FLOOR PLAN — REV E

REV E · 22 SEP 2026 · TO SCALE
ANCHORED ON THE 12×24 GARAGE

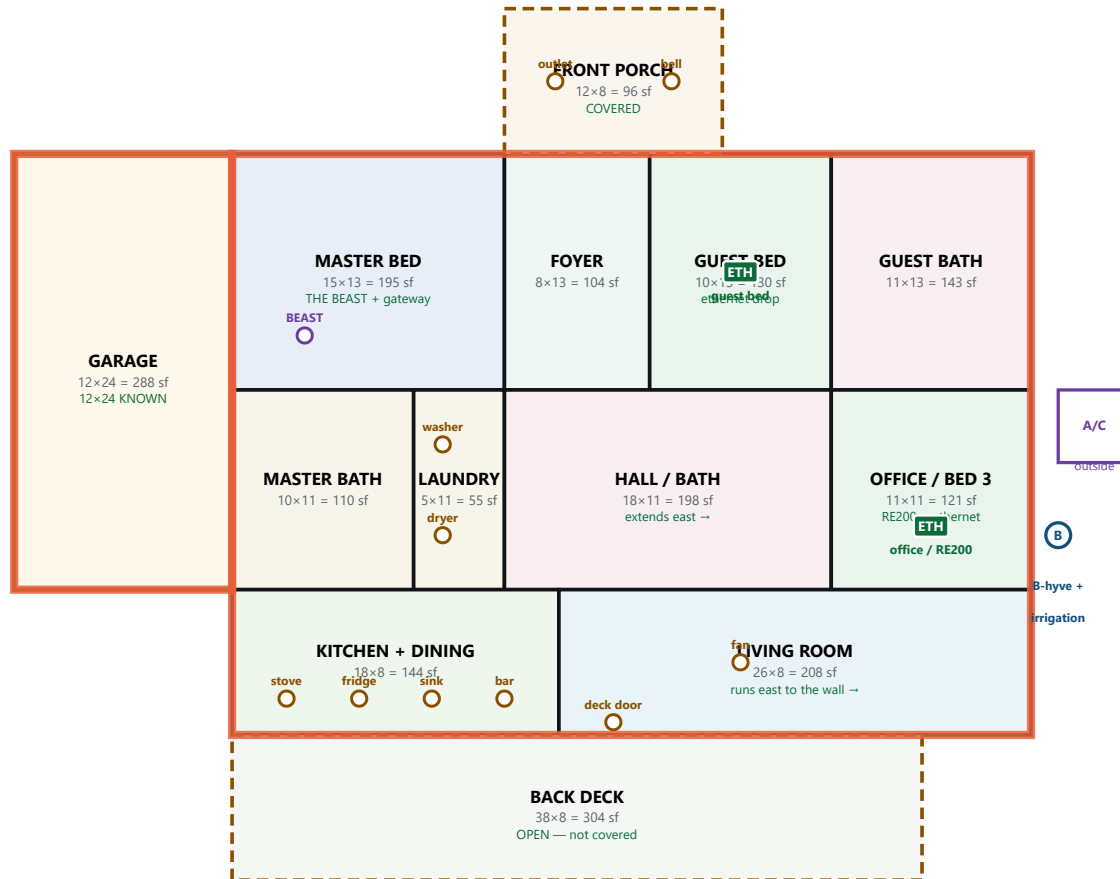
LIVING ROOM RUNS EAST

The living room now runs east to the outside wall with the office sitting directly above it. **Check that reading first** — the panel on the right explains the alternative.

- **The LIVING ROOM now runs east all the way to the outside wall**, and the **OFFICE / BED 3 sits directly on top of it** — they share a wall instead of sitting side by side. That is how I read “the south end of the office ends with the living room.”
- Office is now **11×11 = 121 sf** instead of the 11×19 = 209 sf of Rev D — a sensible bedroom rather than a long corridor.
- Living room is now **26×8 = 208 sf**, the biggest room in the house, which fits a room with 8 LEDs and a ceiling fan in it.

Check this one first — I may have read it backwards. I took “the south end of the office ends with the living room” to mean the living room is **south of** the office. The other reading is that they sit **side by side** and simply end at the same south wall, which is what Rev D already had. **If Rev D was right and this is wrong, say so and I will put it back.**

- **HALL / BATH is $18 \times 11 = 198$ sf** — large, even including a bathroom. Where does the hall actually stop?
- Is the house really **44 wide $\times$ 32 deep**?
- **KITCHEN at $18 \times 8 = 144$ sf** — it shrank when the middle band got deeper. Right?
